Feedback to material classification

23rd Nov 2023

Opinion from OICA to the material classification

Opinion1.Material flow reference

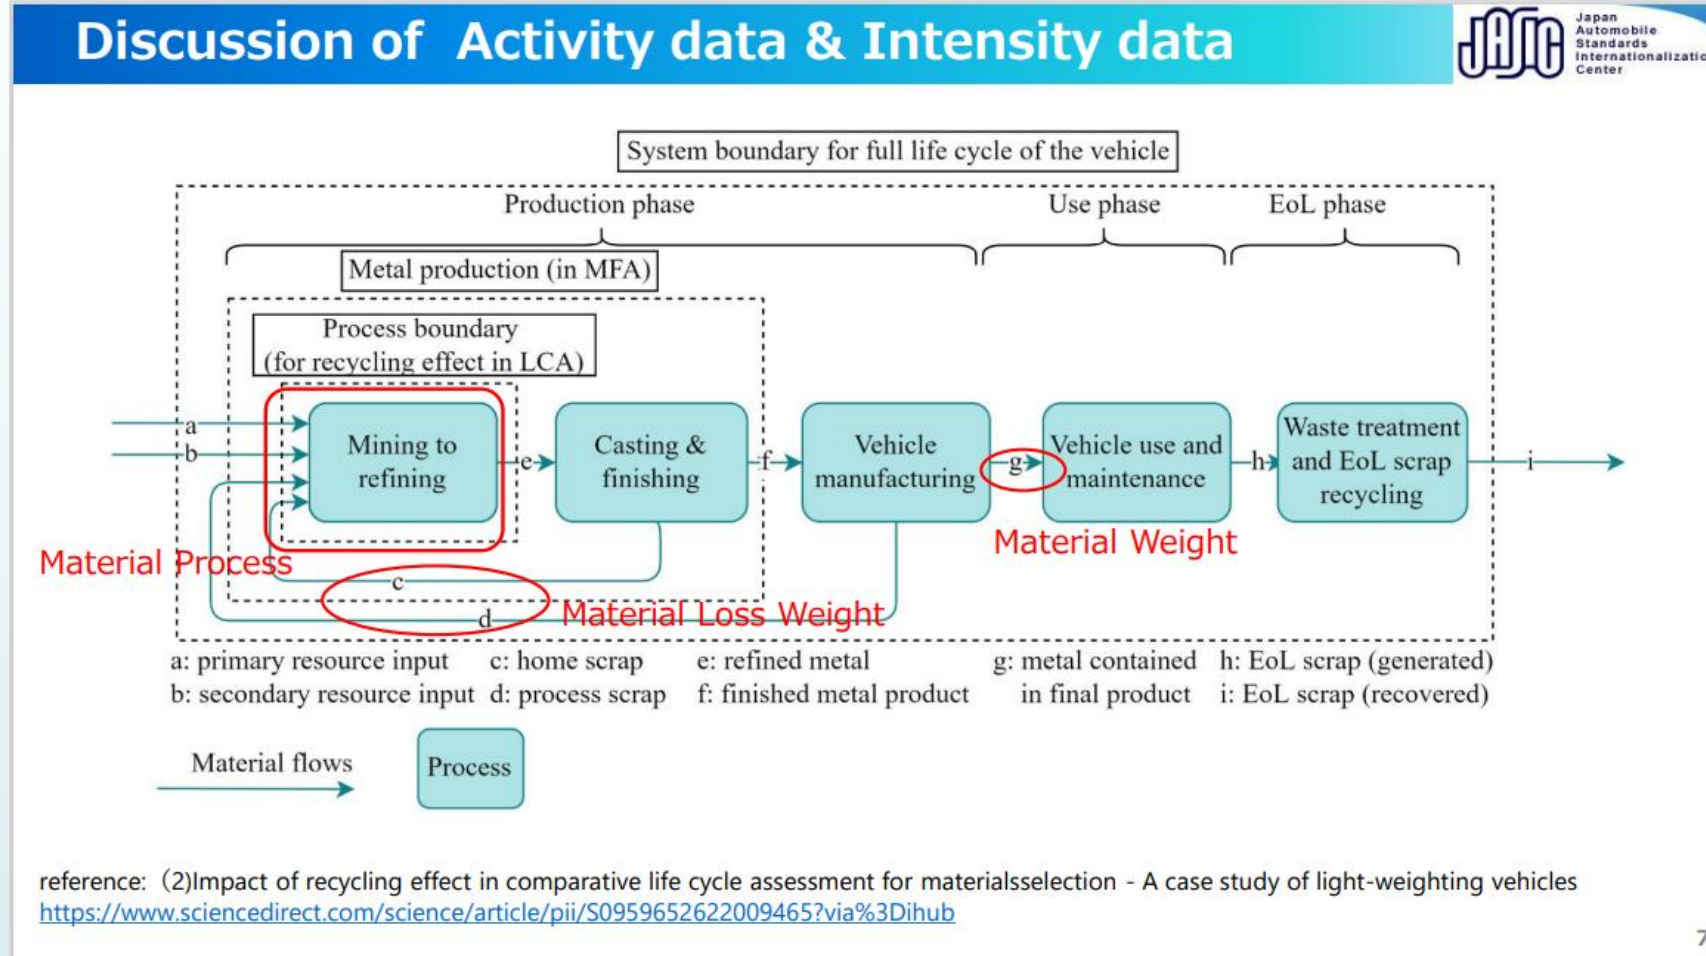
- ✓ We propose to have a reference of process on each material.(Like as below picture)
- ✓ Currently we could see only for steel but should have also for other materials.

Opinion1.Material flow reference

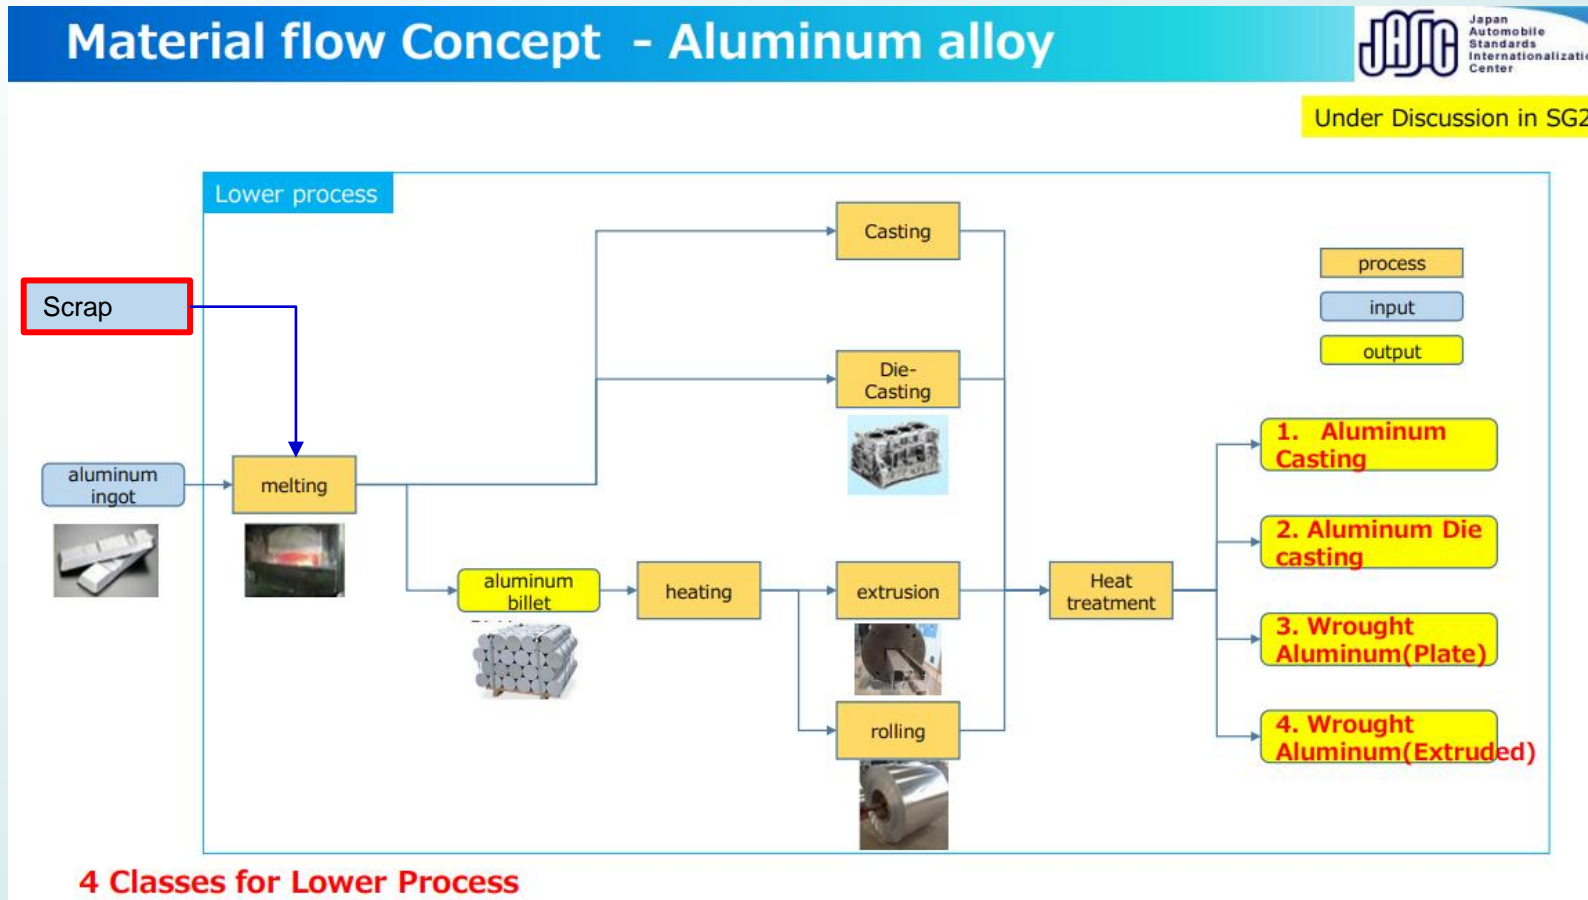
- ✓ Why we are proposing this is we think Aluminum recycle input should also in lower process (melting process)
(We would like to hear an opinion from Aluminum industry.)

Opnion2.Scrap flow

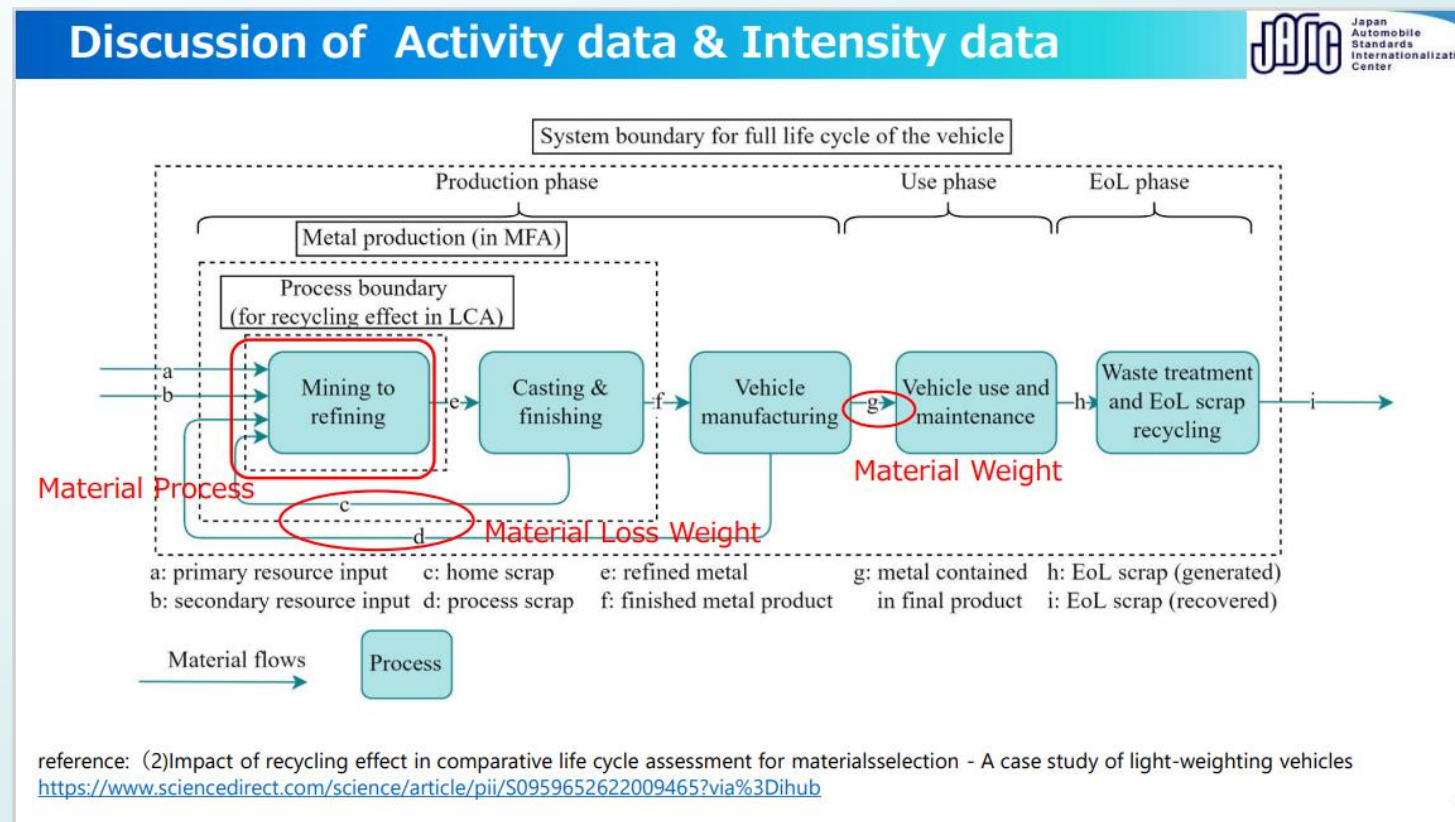
- ✓ We propose to add scrap flow to the process model.
- ✓ However, we understand scrap flow needs to be confirmed with SG5 as boundary discussion.

- Reference model has scrap flow. We propose to add such flow definition on process model.

Opinion4. Electrolysis process naming

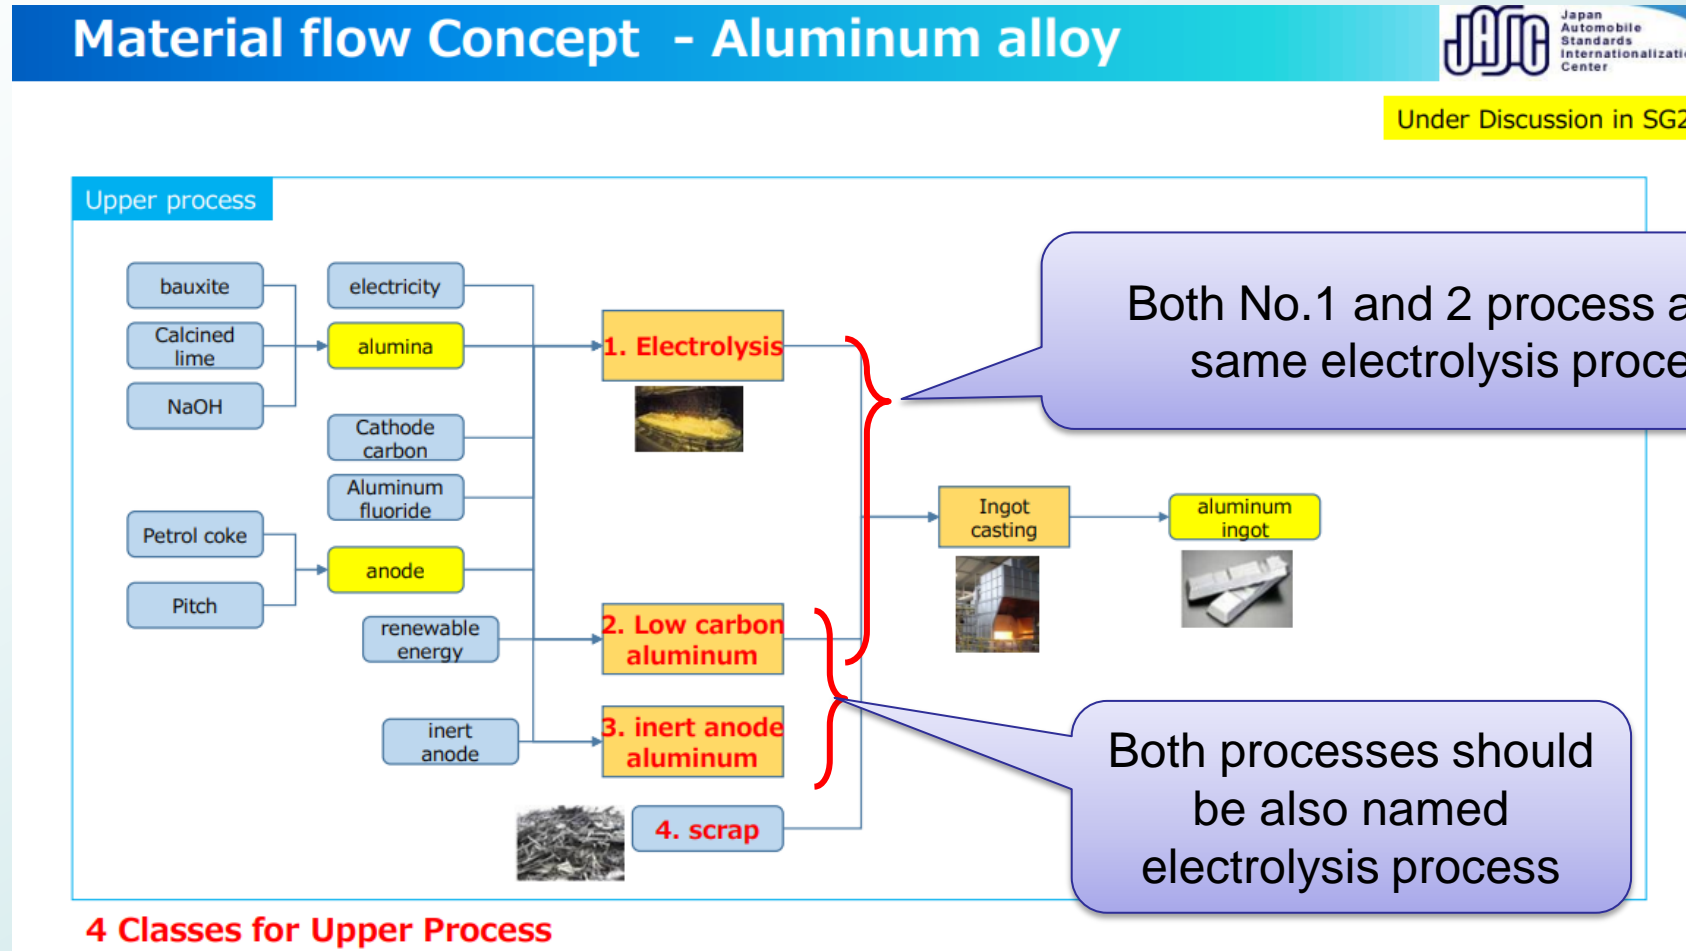
- ✓ Aluminum process 2 and 3 also should be named Electrolysis process like as 1.
- ✓ Then, process 1 and 2 are same electrolysis process. (Both could be merged to one process.)
